IMPROVED AGRICULTURAL PRACTICES FOR RICE CULTIVATION IN INDIA VALIDATION REPORT

Document Prepared by Carbon Check (India) Private Limited

Project Title	Improved Agricultural Practices for Rice Cultivation in India (project ID: 4032)
Version	2.0
Report ID	CC IPL1752/VCS/VAL/IAPII/20230202

Report Title	Improved Agricultural Practices for Rice Cultivation in India Validation Report
Client	Kosher Climate India Pvt. Ltd.
Date of Issue	21 st September 2023
Prepared By	Carbon Check (India) Private Limited

Figure 1: Project area map for first instance

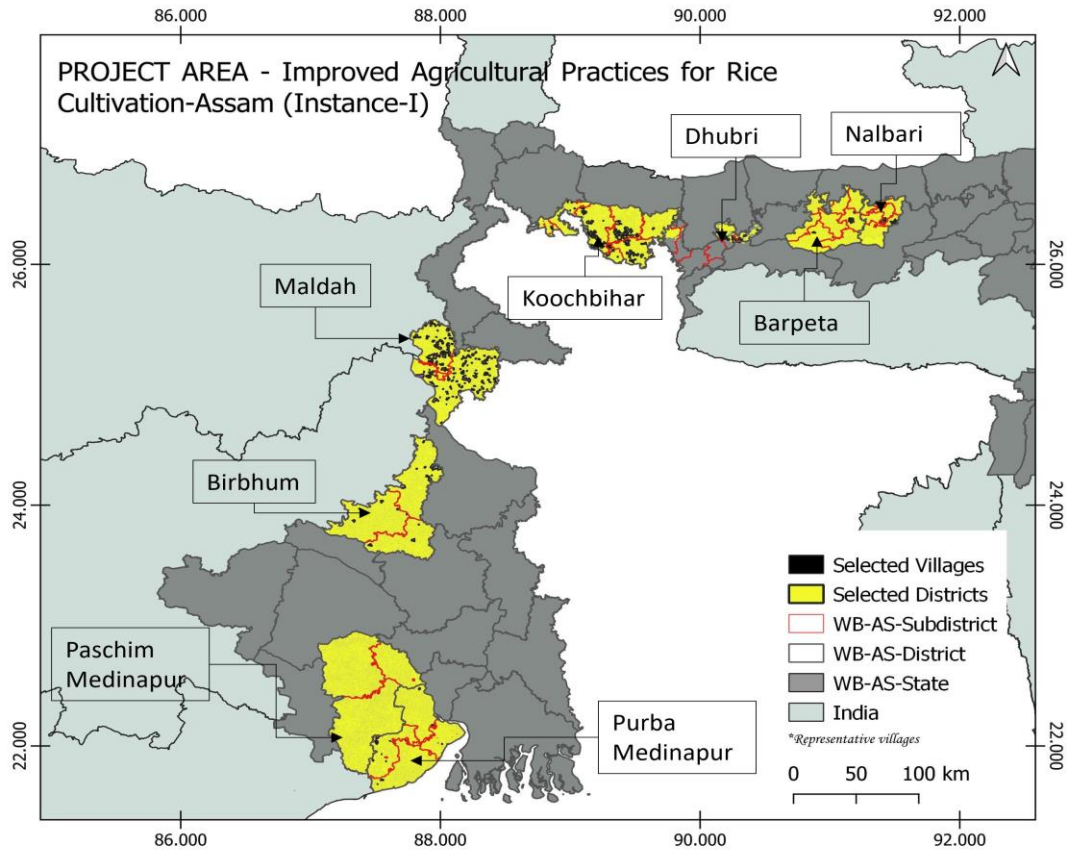
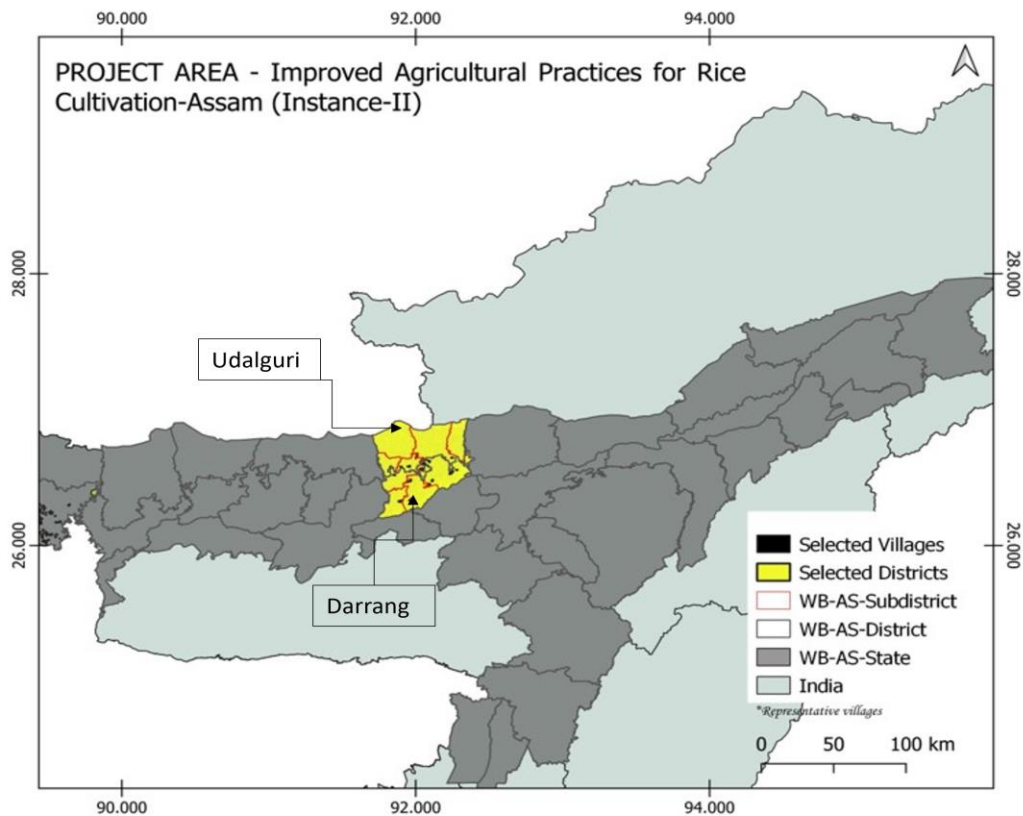
Project proponent is requested to provide the map of the project geographical boundary(districts) covered in the first two instances in the section 1.12 of the PD. Project participant is requested to add (in section 1.12 of PD) all relevant information provided in the para 3.11.2 -3.14.4 of VCS standard version 4.4

2. A district wise maps for both the instances have been revised and updated

It has been observed that the typographical error has been corrected in the PD. A Map of the project location for both the instances has been added in the PD.

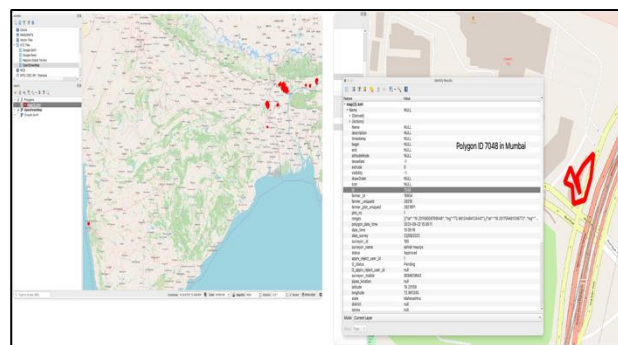
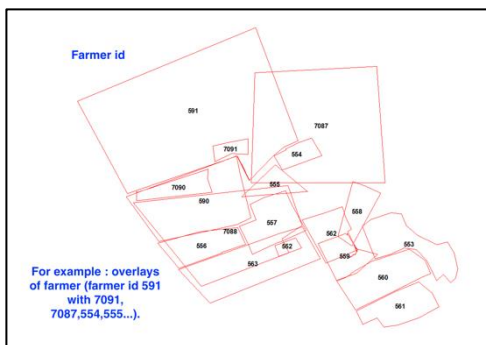
- 4- There are polygons of project area completely inside or with a relevant area inside of the forest for LULC 2012 (there are 334 polygons), two of those polygons appear completely inside or relative inside of the forest for 2012 and 2017 and one polygon still is inside of the forest for LULC 2012-17-22. (Please check the shapefile "Polygons_in_forestLULC2012.shp; Polygons_in_forestLULC2012and2017.shp")

- 5- In the LULC 2017 there are 185 polygons completely inside or with a relevant area inside of the forest. (Please check the shapefile "Polygons_in_forestLULC2017.shp")

Project Proponent response

Since project proponent was not bel to provide the project field polygons for the entire area, the LULC analysis of the whole project area could not be completed. Based on the analysis of the LULC maps, shapefiles and the polygons provided for the 2500 ha of the project area out of 13,169 ha, it has been confirmed that the 2500 ha of land has not been cleared of native ecosystem since past 10 years.
